**BEST STREAM AND WETLAND RESTORATION PROJECT  
MONITORING REPORT  
MONITORING YEAR 3  
FINAL**

DUPLIN COUNTY, NORTH CAROLINA  
CONTRACT No. 004631 - PROJECT No. 95353  
USACE Action ID No. 2012-01384 -NCDWR Project No. 13-0865

RE: Best Stream and Wetland Restoration Site: MY3 Monitoring Report (NCDMS ID 95353)

Listed below are comments provided by DMS on January 31, 2018 regarding the Best Stream and Wetland Restoration Site: Year 3 Monitoring Report and RES' responses.

**Table 15b. MY1, MY2, MY3 Wetland Hydrology Gauge Summary**

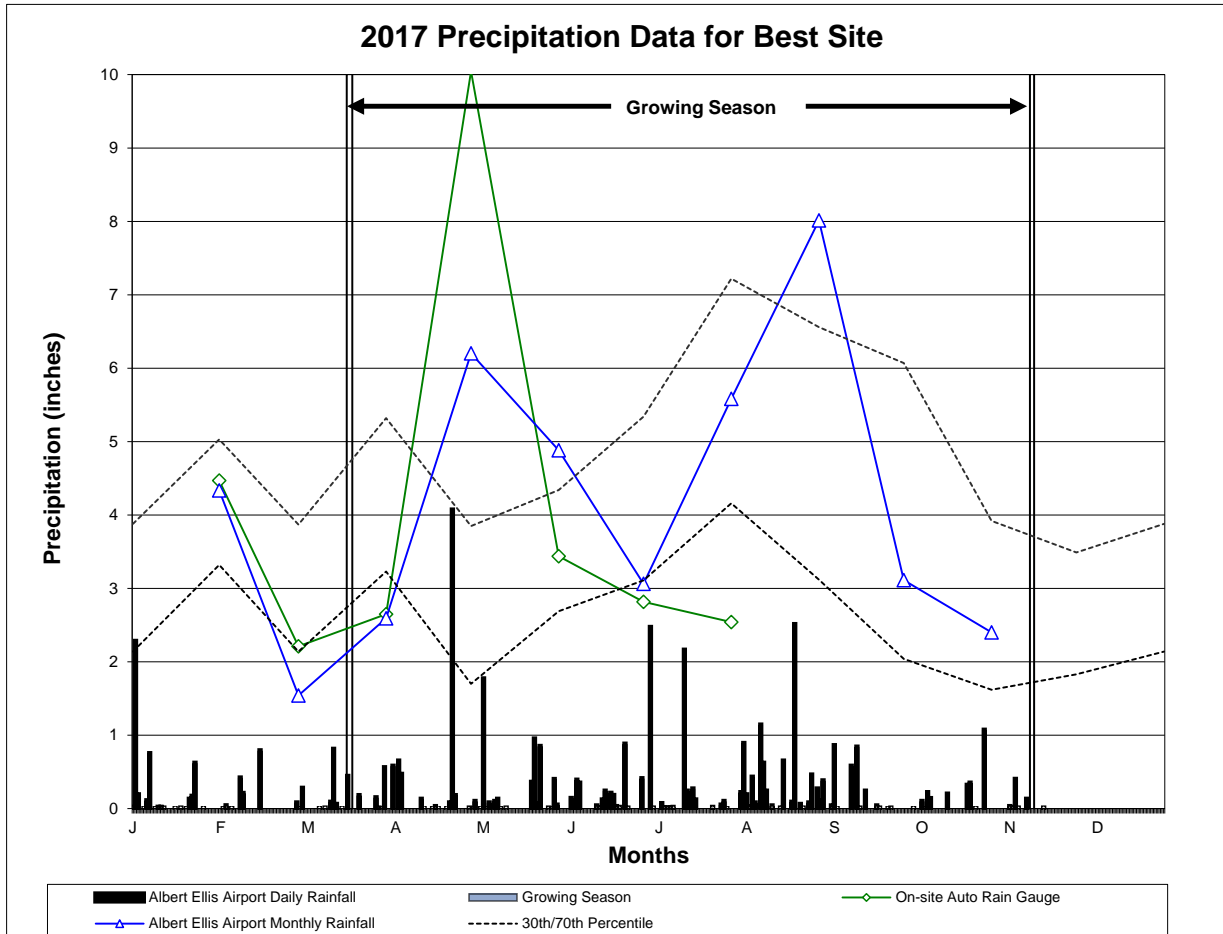
Executive Summary, page iii: Explain why gauges AW8 and AW9 failed to collect data for the first half of the growing season and whether these gauges have been repaired.

[Done.](#)
